## AMENDMENT REPORT:

### PROPOSED OVER STATION DEVELOPMENT AT CROWS NEST - SITE B

**SSD-61400212**

25 HUME STREET, CROWS NEST  
LOT 3 DP 1296669

**Figure 14. Ground Level Comparison - Old Built Form on the Left and New Built Form on the right. (Source: Woods Bagot, 2025)**

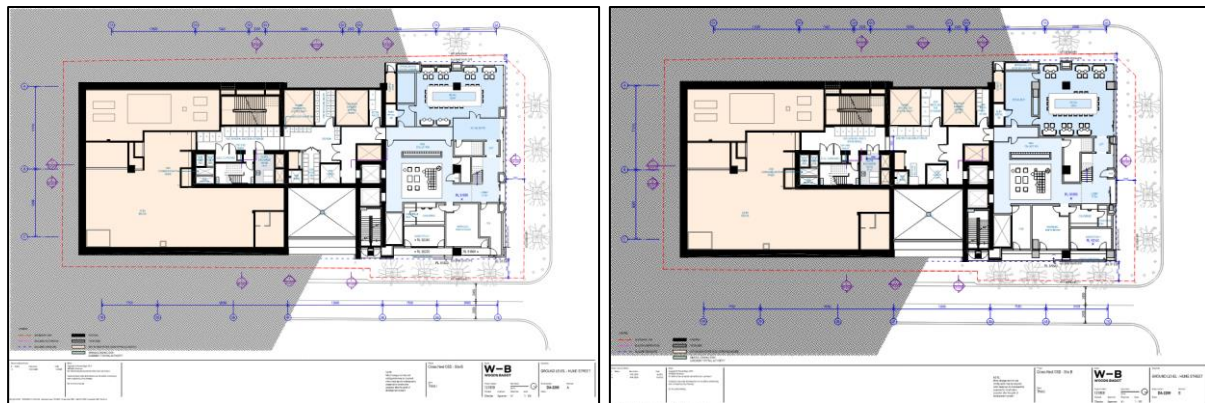
- **Level 02** – no change.
- **Level 05** – the layout has been adjusted having regard for structural requirements associated with the transfer slab. The walls of the carpark have been moved outward and the landscape elements have been removed. One (1) additional car parking space is provided. Bike parking has been removed from this Level.

**Figure 23. Lower Penthouse Level 19 Comparison - Old Built Form on the Left and New Built Form on the right. (Source: Woods Bagot, 2025)**

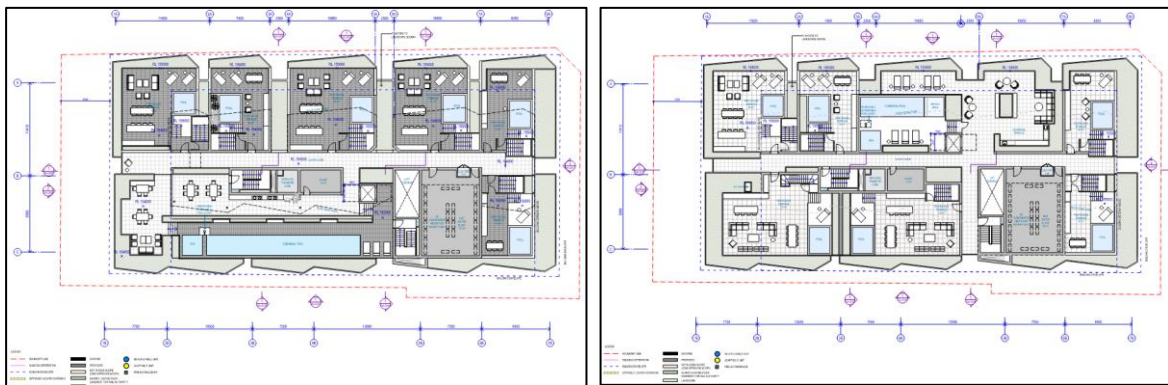
- **Level 17-18** – Minor apartment reconfiguration.
- **Level 19** – Minor apartment reconfiguration.
- **Level 20** – Minor apartment reconfiguration.
- **Roof Terrace** – Minor reconfigured to provide greater privacy for future residents having regard for the built form changes introduced via the Crows Nest TOD rezoning.
